INFORMATION REQUEST

APPLICATION NO: MCUI/48/2026
PROPERTY ADDRESS: 31 BAHRS SCRUB ROAD, BAHRS SCRUB QLD 4207
PROPERTY DESCRIPTION: LOT 1 RP 162767
APPLICATION DESCRIPTION:
• **MATERIAL CHANGE OF USE – CHILDCARE CENTRE**

Figure 1:

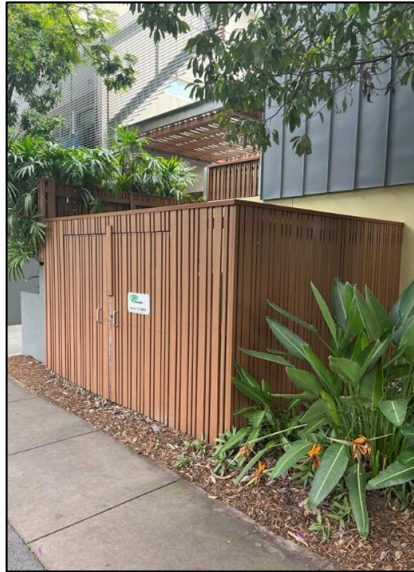
- 2.2.7. Screening around the pad mount transformer (PMT) to screen it from the streetscape and adjoining premises;

Screening may include fencing with a maximum transparency of 50% or landscape screening. Refer to Figure 1 below for how this outcome may be achieved. Further information may also be found via the following link: [Development Adjoining Padmounts Guideline](#)
